SUBJECT: Response to National Remedy Review Board Recommendations on the
Continental Steel Superfund Site, Kokomo, Indiana

Re: Response to NRRB Recommendations and
EPA Comments

**Continental Steel Superfund Site
Focused RI/FS**

**Response to National Remedy
Review Board Recommendations**

SCHEMATIC LAYOUT FOR MARKLAND AVENUE QUARRY SOURCE CONTROL ALTERNATIVE SC-30

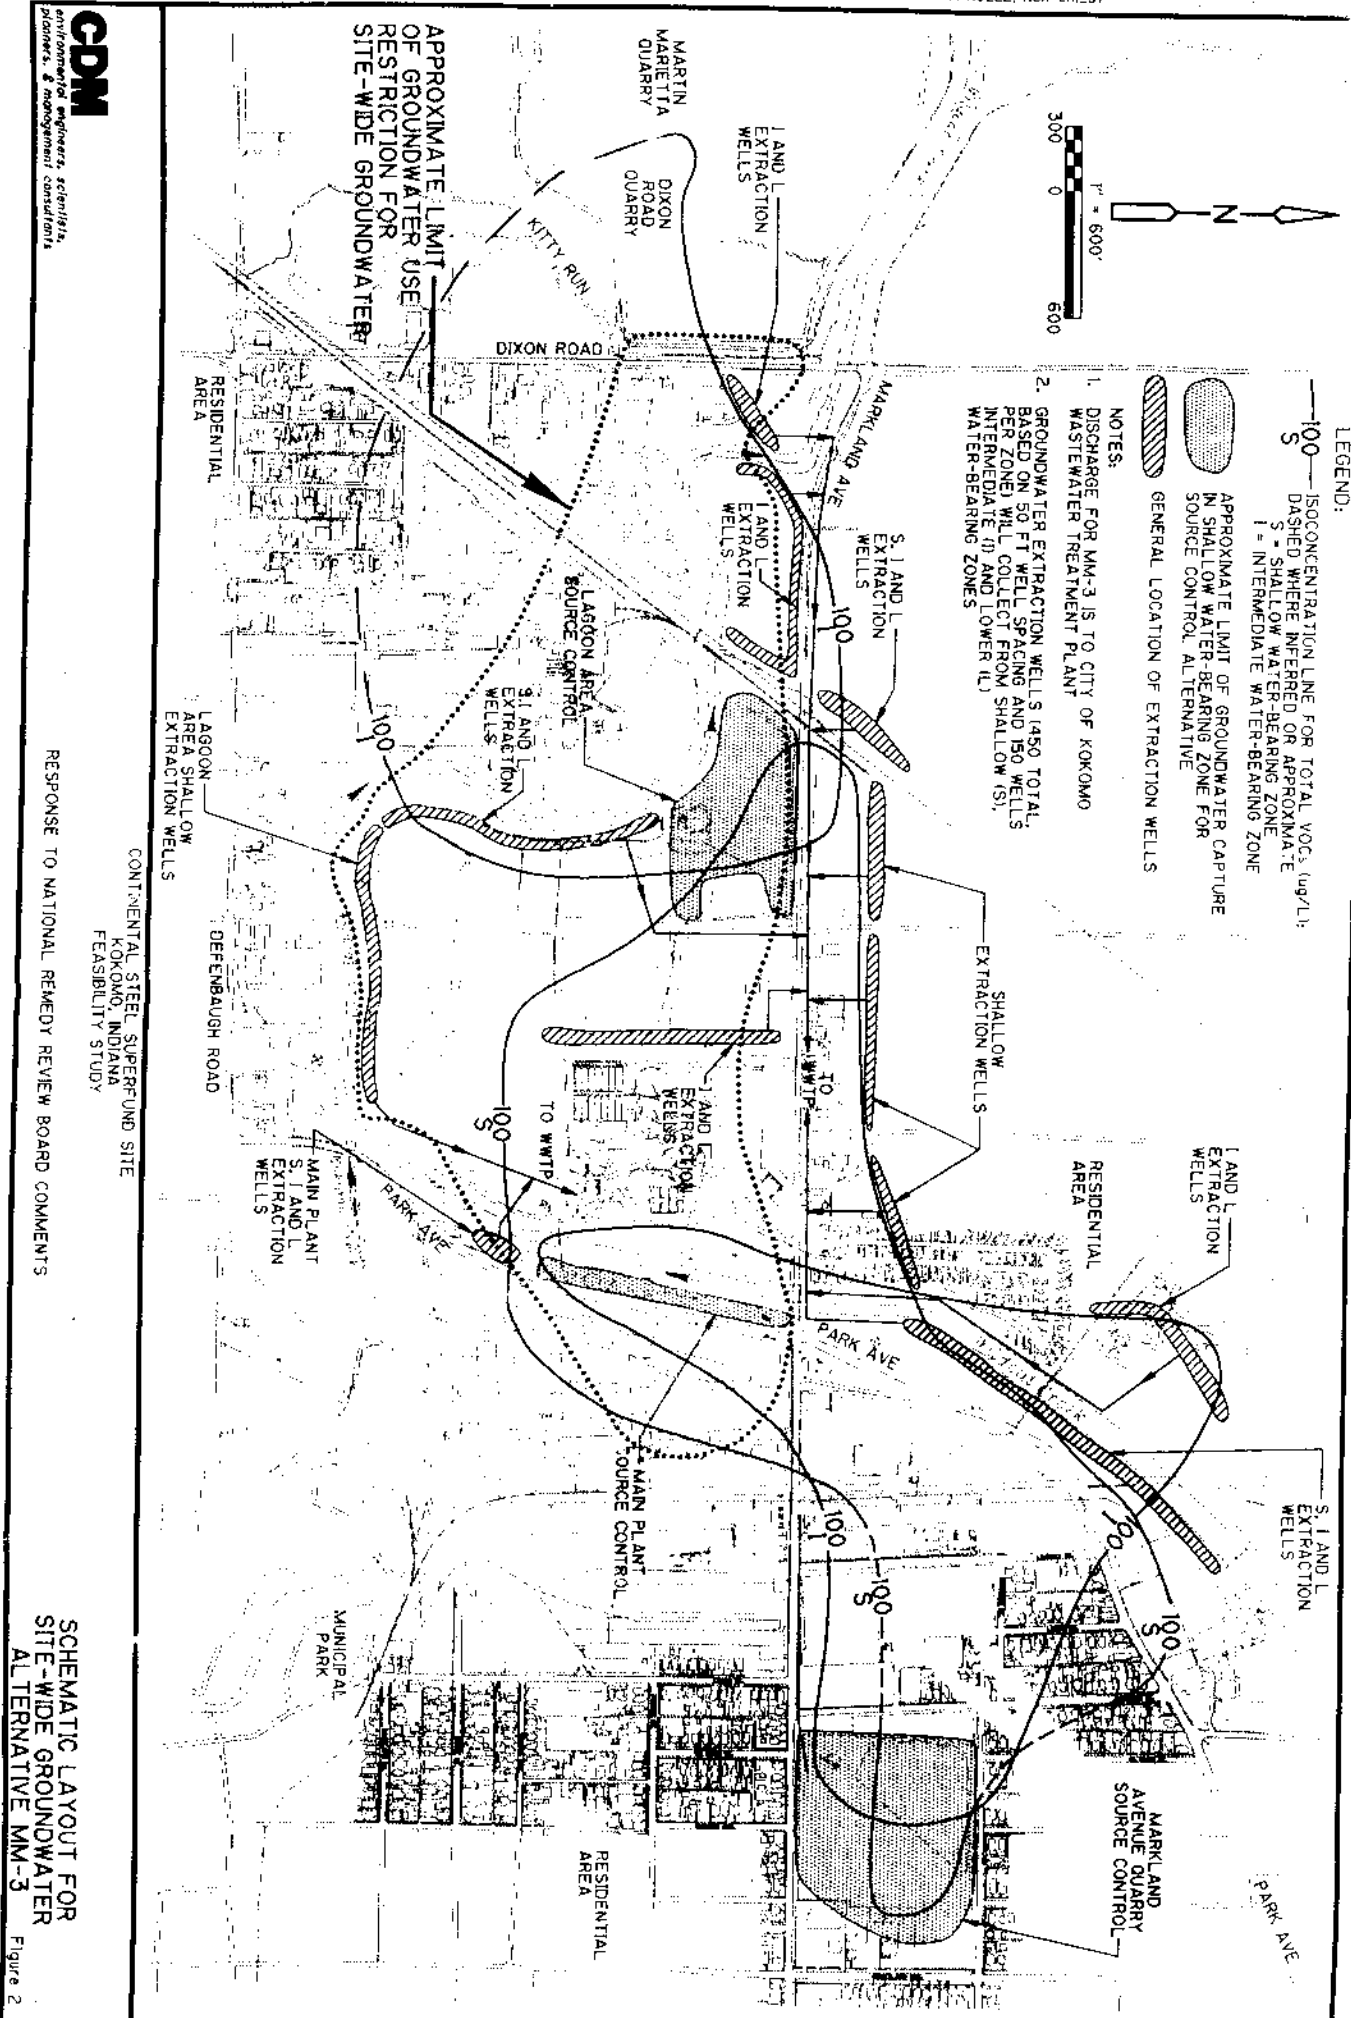
The State should evaluate the appropriateness of locating ground water extraction in the immediate vicinity of the [Markland Avenue] quarry in order to maximize control over potential plume migration westward toward the creek. For the area between the recovery system and the creek the State should investigate monitored natural attenuation as an alternative to the proposed recovery system to restore the shallow groundwater.

For the Markland Avenue Quarry, alternative SC-3Q includes a system of extraction wells located along the western and northern perimeter of the quarry to intercept groundwater in the shallow water-bearing zone. This is shown in Figure 1. This line of extraction wells was situated immediately downgradient of the source area and can be considered in close proximity to the source area. In addition to the interception component, this system would also generate a capture area that should recover some contaminated groundwater in the shallow water-bearing zone that has already migrated from the source area. By inference, this alternative includes groundwater use restrictions and intrinsic remediation in the downgradient areas that were predicted to be affected by the migration of groundwater contamination that could not be recovered by the selected site-wide alternative. Alternative SC-3Q focused on the containment and collection of groundwater in the

Upon further review, the State concurs with the NRRB's recommendation because it should achieve ARARs in shorter timeframe in this vicinity and is more compatible with guidance given for justification of the groundwater TI waiver (i.e., implementation of source controls to the extent practical). The State agrees that shallow groundwater control as described in SC-3Q in lieu of adjacent to the creek as described in MM-5 is desirable, even though it will add approximately \$50,000 to the suggested remedy for the site as a whole. This increase in cost of the site-wide remedy is reflected by an increase in the estimated cost of the preferred alternative for Markland Avenue Quarry (2.5Q) of \$390,000 and a decrease in the estimated cost of the preferred alternative for site-wide groundwater (MM-5) of \$340,000.

CONCEPTUAL CROSS-SECTIONAL VIEW OF CAMU LANDFILL

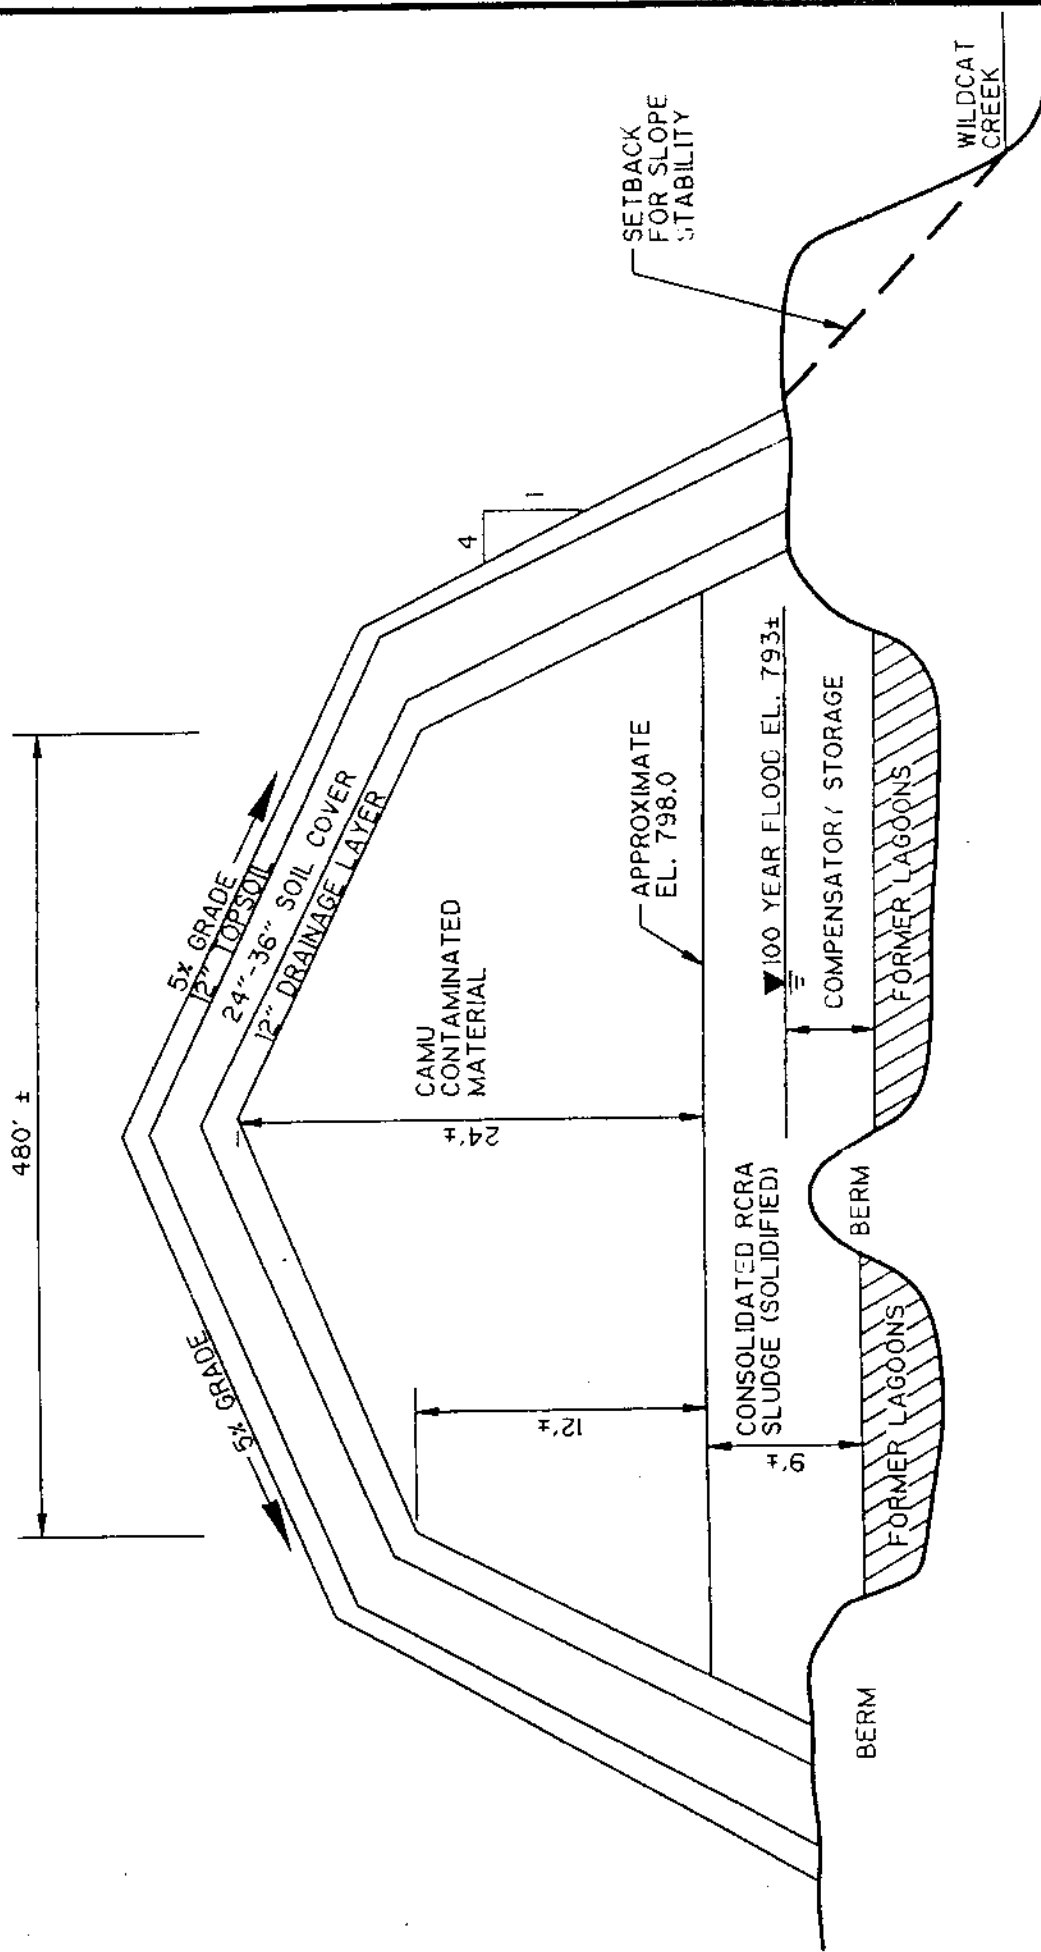
The Board believes that there may be alternative (lower cost) approaches to constructing the proposed "Corrective Action Management Unit" in the lagoon area. For example, adequate dewatering and stabilization of the sludge may be achieved by surcharging the area to achieve load bearing capacity; while adequate cap performance may be achieved using the surcharge soils and proposed impermeable material. The Board recommends that the State evaluate the feasibility of this or similar approaches.
